Revision Control Record

SW,SPDT,MOM,TOGGLE,SW

551844

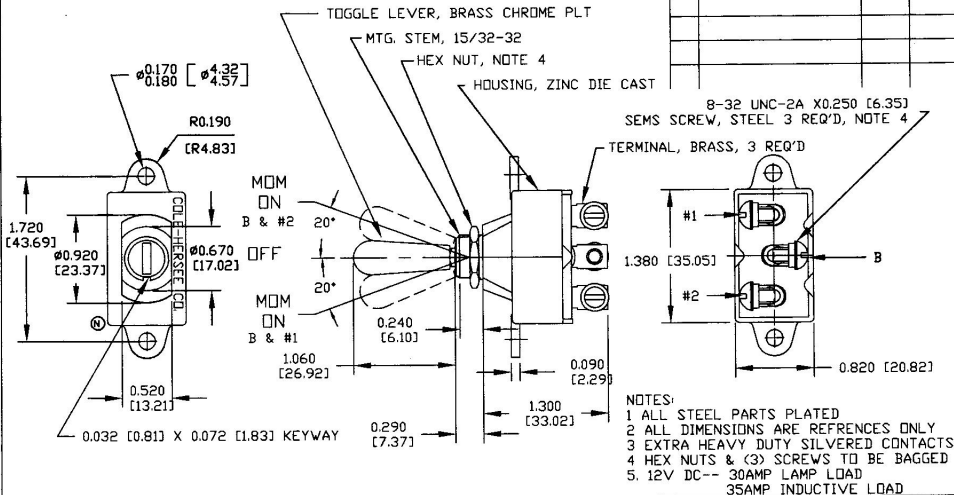
Rev.	Description of Change	ECN No.	Date
N	DELETE 'BOSTON U.S.A'	04449	11/05/04
